Approval no: DEV2024/1479

Our Reference: NA250253
Your Reference:

Re: 15-21 Wren Street, Bowen Hills – Responses to EDQ Further Issues Letter
(DEV2024/1479 dated 31 May 2024)

This letter and enclosures outline responses to Items 22, 23 and 24 of the EDQ Further Issues Letter
(DEV2024/1479 dated 31 May 2024).

Drawing Title CIVIL SERVICES CONCEPT BULK EARTHWORKS PLANS				
Drawn JAM	Designed KU	O.A. Check CR	Date 05.03.25	Scale @ A1 1:100
Project No. NA250253	Drawing No. SKC04-0001	Issue A

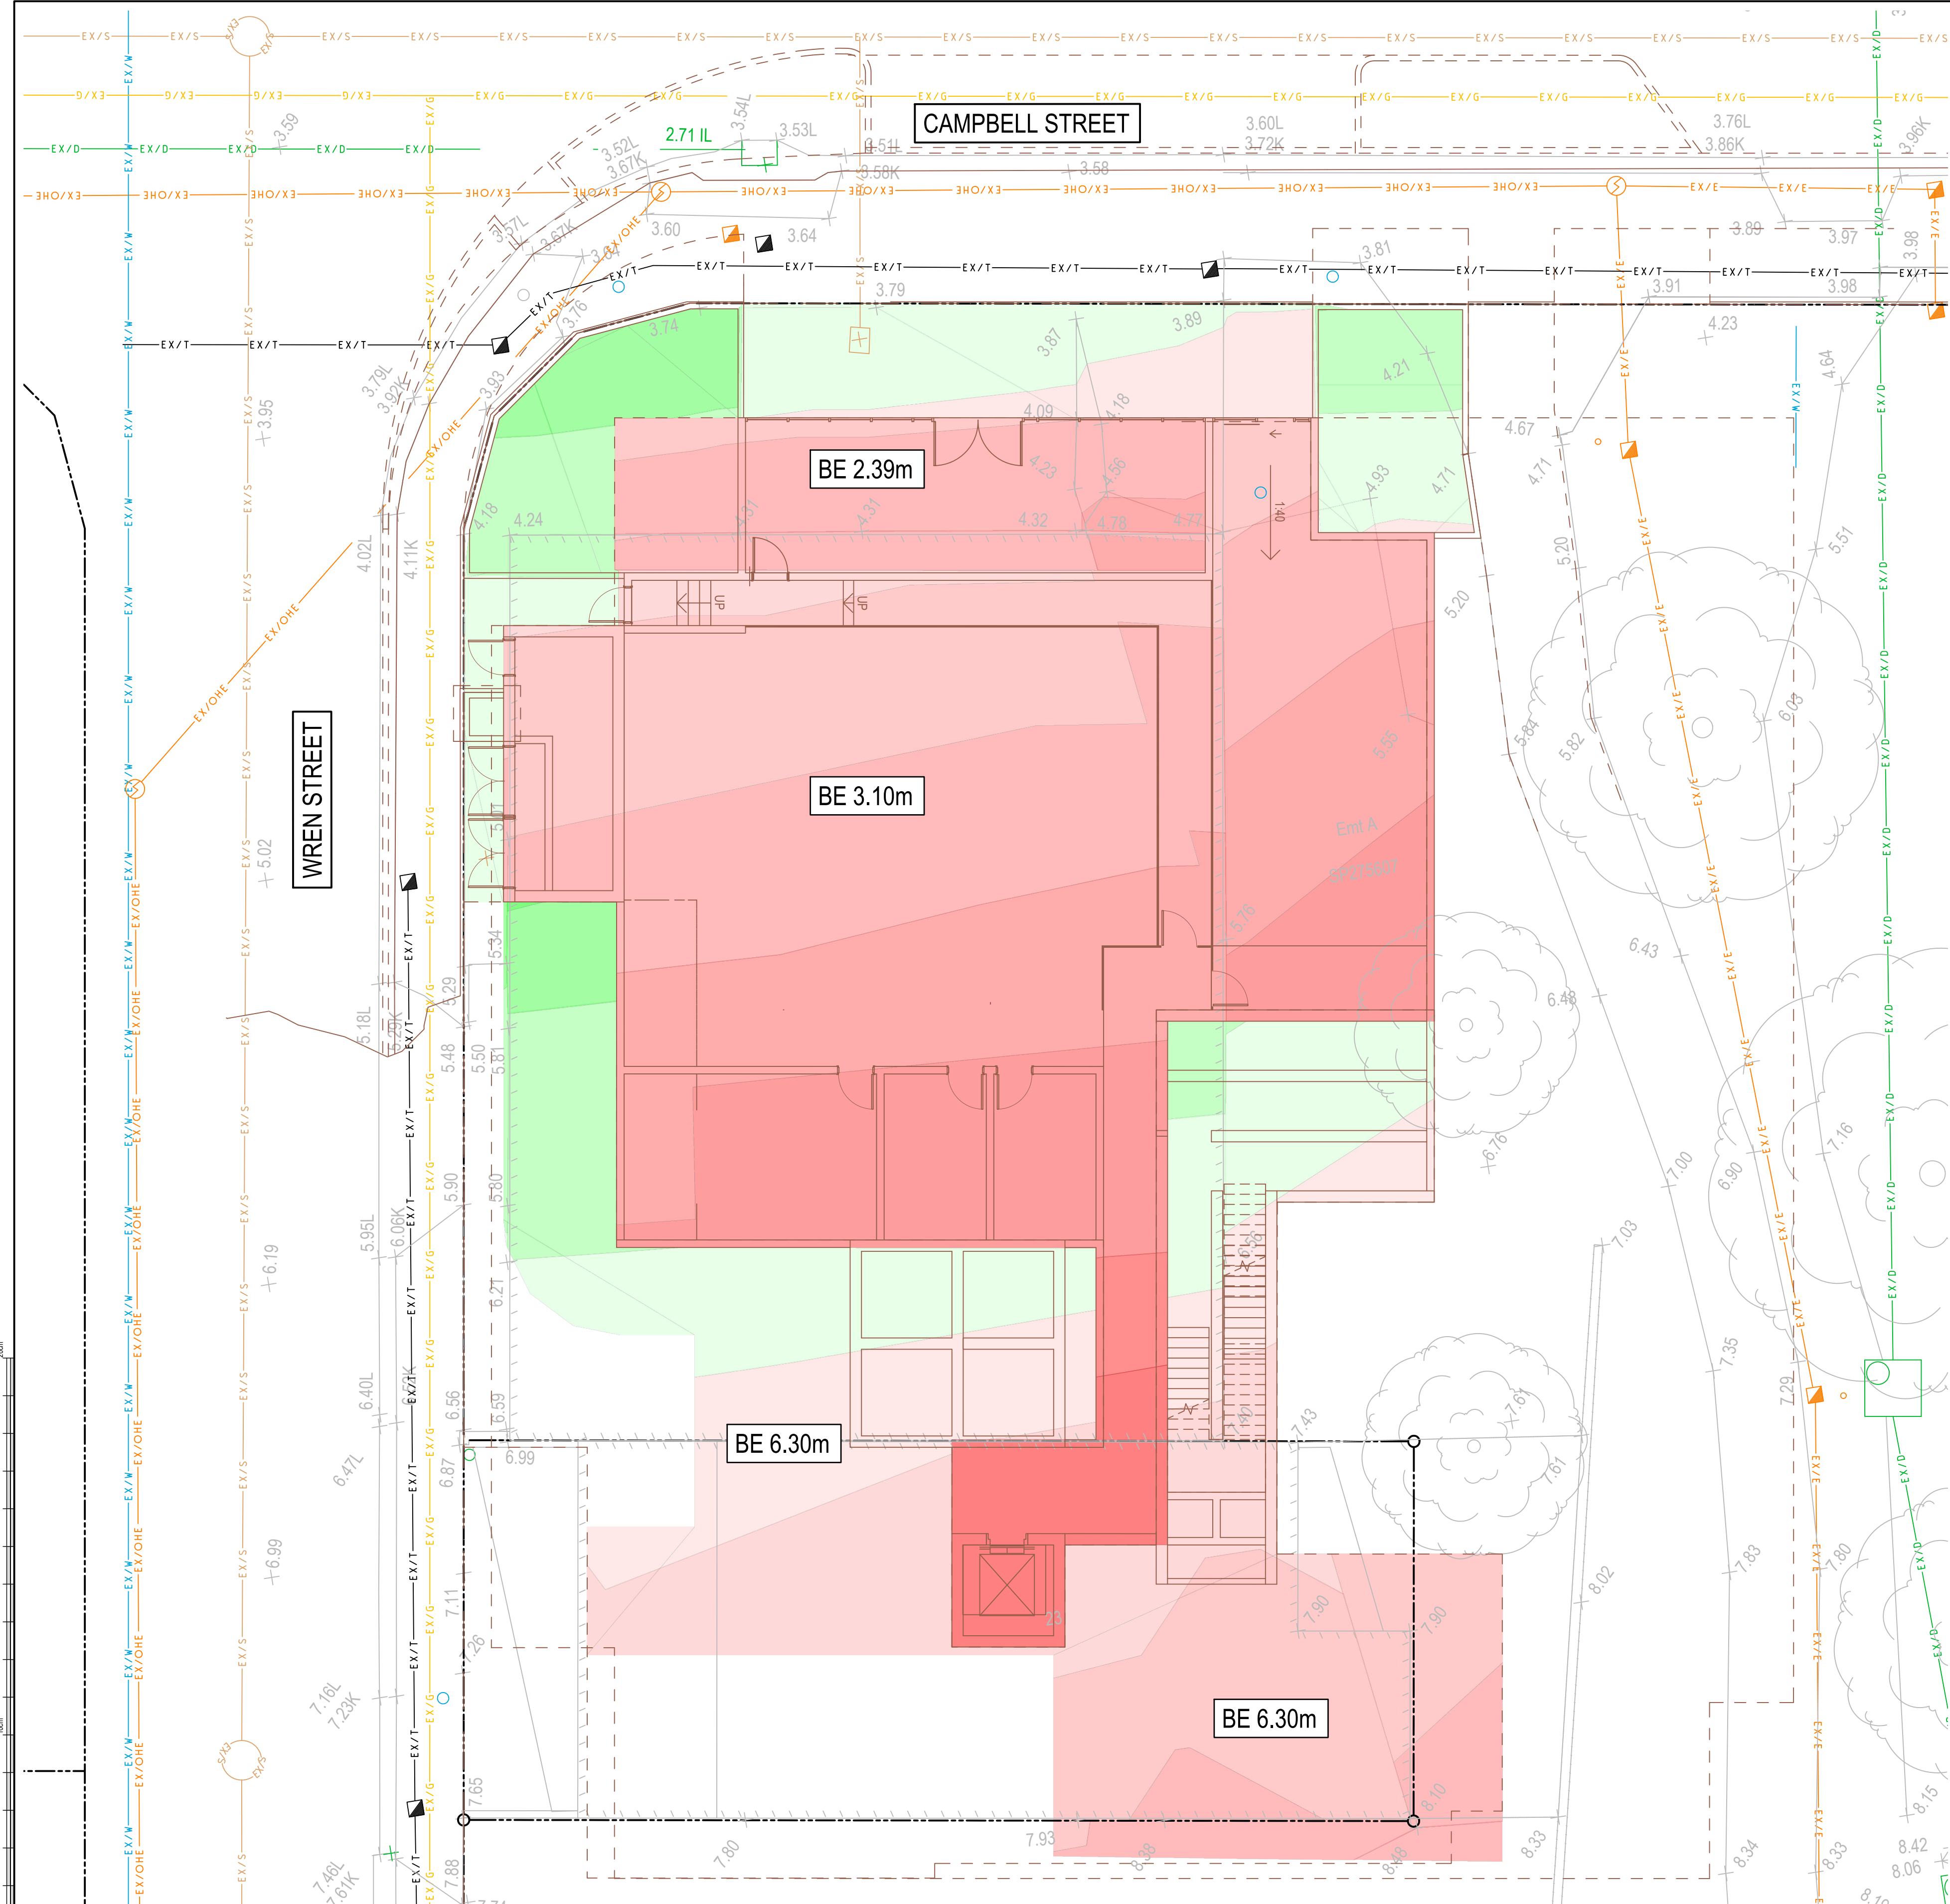
Item 23 – Flood storage compensation		
Item No.	Response	Documentation reference (enclosures)
Item 23 a.	An earthworks cut and fill plan has been prepared showing the flood storage calculation.	<ul style="list-style-type: none"> Refer to concept bulk earthworks plan by ACOR Consultants.

Drawing Title CIVIL SERVICES CONCEPT STORMWATER MANAGEMENT PLAN				
Drawn JAM	Designed KU	O.A. Check CR	Date 05.03.25	Scale @ A1 1:100
Project No. NA250253	Drawing No. SKC08-0001	Issue A

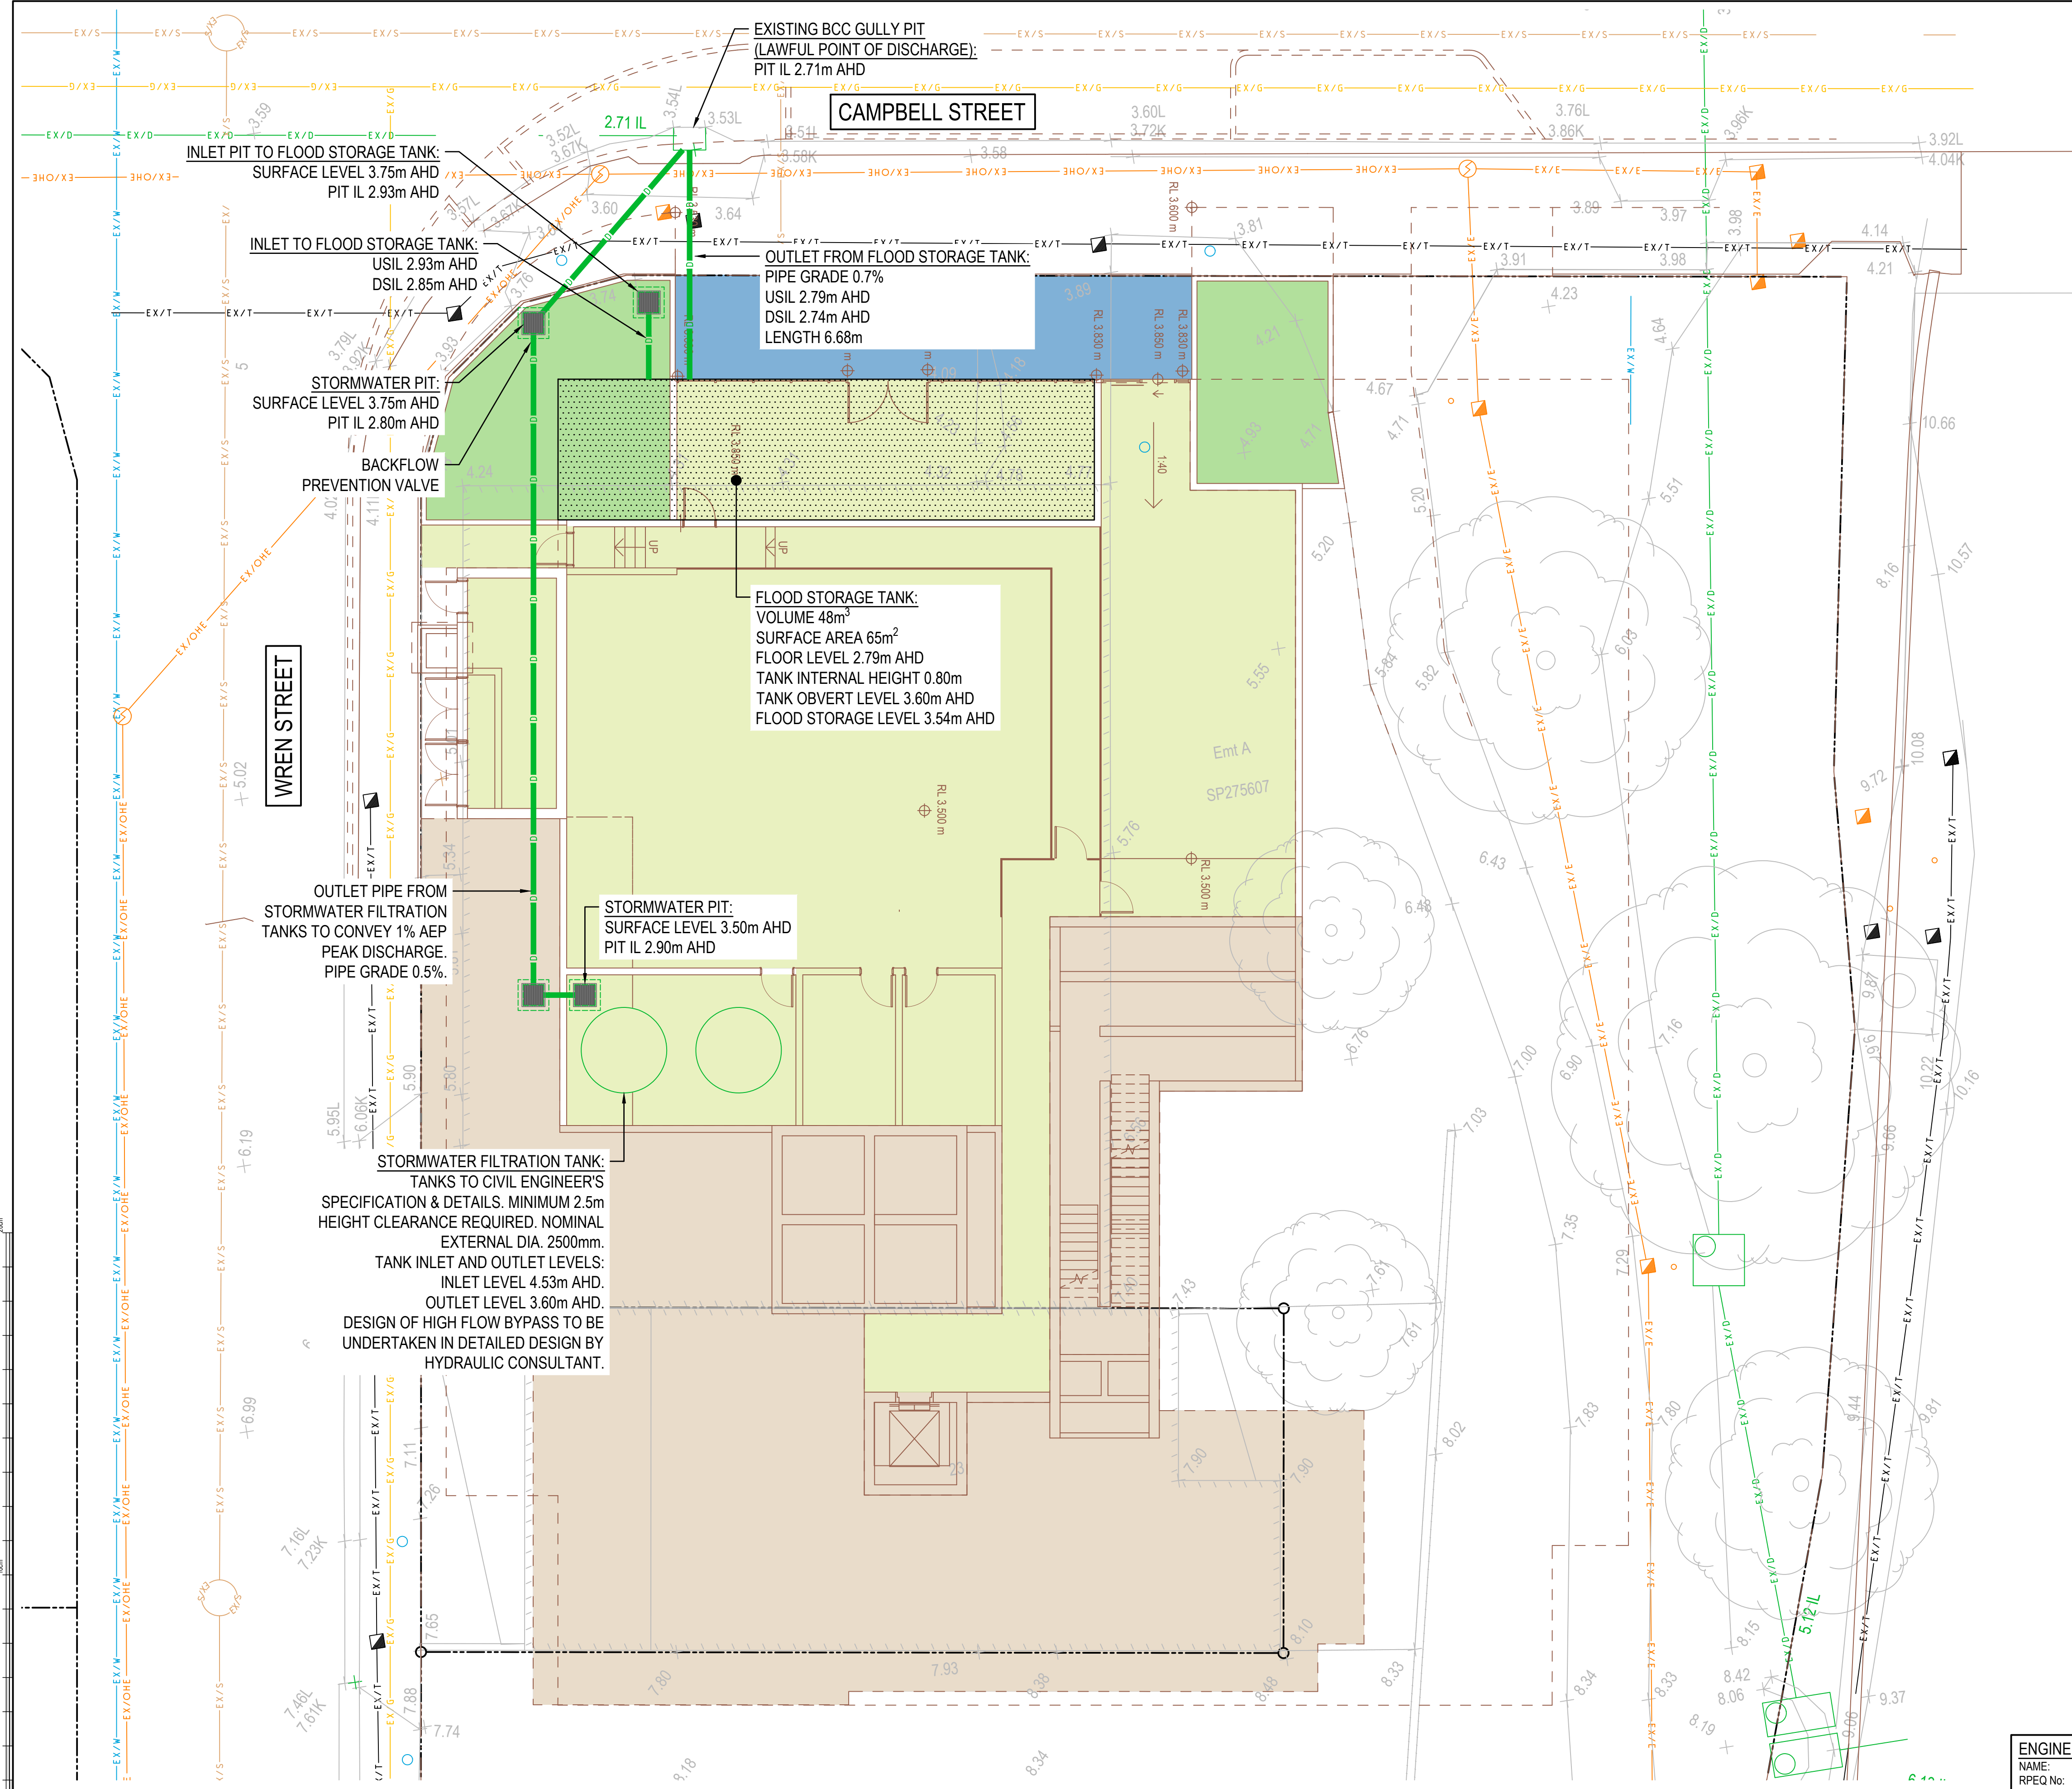
Item 23 b.	<p>A plan showing the location of the underground tank, inlet chamber, and outlet pipe level (m AHD) in relation to the lawful point of discharge (LPD) has been prepared.</p> <p>The lawful point of discharge for the site is the existing gully inlet pit (BCC asset ID K15091997) in Campbell Street (near corner of Wren Street).</p>	<ul style="list-style-type: none"> Refer to concept stormwater management plan by ACOR Consultants.

Item 23 c.	The flood storage tank will be emptied after every flood event so it is ready for the next flood event. The tank will drain by gravity flow via pipe (size to be determined in detailed design) to the existing gully inlet pit (BCC asset ID K15091997) in Campbell Street (near corner of Wren Street).	<ul style="list-style-type: none"> Refer to concept stormwater management plan by ACOR Consultants.

Item 24 – Stormwater Management Plan		
Item No.	Response	Documentation reference (enclosures)
Item 24	<p>The stormwater quality tanks will drain by gravity flow via pipe (size to be determined in detailed design) to the existing gully inlet pit (BCC asset ID K15091997) in Campbell Street (near corner of Wren Street).</p> <p>The attached plan shows the location of the stormwater quality tanks on the lower ground floor, inlet and outlet levels and outlet pipe gradients.</p>	<ul style="list-style-type: none"> Refer to concept stormwater management plan by ACOR Consultants.
